Access Compliance Report Public Rights-of-Way (Curb Ramps)

Main Street: WALLINGSFORD_RD		Cross Street: HUNTLEY_DR		Location:	NE
ADA ID: RPRK211215142055	Ramp Type:Type 1 - Perpendicular Diagonal Initial Pass/Fail: Fail		Overall Compliance: No	Severity Score:	16
Codes/Mitigation Info/Possible Solution			Field Measurements/Component Compliance

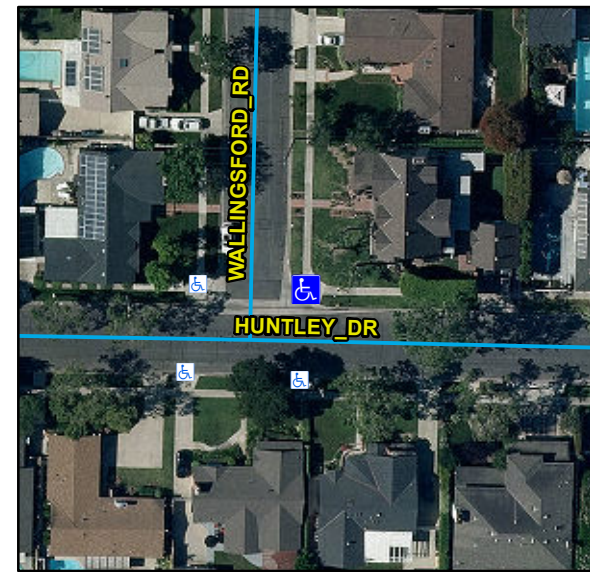
R204.3, R304.2.2, R304.5.3, STD 1115

Compliance	Description	Data	Compliance	Description	Data
N/A	Ramp Length (in)	81	N/A	Flare Type LT	
Yes	Ramp Width (in)	48			N/A
No	Ramp Run Slope (%)	8.4	N/A	Flare Slope LT (%)	N/A
No	Ramp Cross Slope (%)	2.7	N/A	Flare Traversable LT	N/A
N/A	Landing Present	N/A	N/A	Flare Type RT	
N/A	Landing Length (in)	N/A			N/A
N/A	Landing Width (in)	N/A	N/A	Flare Slope RT (%)	N/A
N/A	Landing Run Slope (%)	N/A	N/A	Flare Traversable RT	N/A
N/A	Landing Cross Slope (%)	N/A	N/A	DWS Provided	N/A
N/A	Landing Movement Obstructed?	N/A	N/A	DWS Contrast	N/A
	Landing Movement Type	N/A	N/A	DWS Length (in)	N/A
N/A	Landing Shared	N/A	N/A	DWS Full Width	N/A
N/A	Clear Space	Yes	N/A	DWS Offset Left (in)	N/A
N/A	Clear Space To Crosswalk (in)	N/A	N/A	DWS Offset Right (in)	N/A
N/A	Marked Crosswalk 1	No	N/A	Marked Crosswalk 2	No
	Crossing 1 Direction	W		Crossing 2 Direction	S
	Marked Crosswalk 1 Width (in)	N/A		Marked Crosswalk 2 Width (in)	N/A

N/A	Ramp Inside Crosswalk 1	N/A	Yes	Ramp Inside Crosswalk 2	N/A
	Crossing 1 Slope (%)	4.5		Crossing 2 Slope (%)	7.4
	Crossing 1 Cross Slope (%)	0.1		Crossing 2 Cross Slope (%)	2.9
N/A	Gutter Ponding	N/A	N/A	Curb Slope	3.5
Yes	Gutter Lip Height (in)	0		Road Run Slope (%)	0.8
N/A	Gutter Run Slope (%)	N/A		Road Cross Slope (%)	1.6
N/A	Gutter Cross Slope (%)	N/A			
Yes	Overall Surface Condition: Acceptable		No	Perp Joint Present	No
	Cross Gutter Present?	Yes		Spandrel Present?	Yes
	Replace Cross Gutter?	No		Replace Spandrel?	No

Remove & Replace Curb Ramp With Two New Directional Ramps or Equivalent.
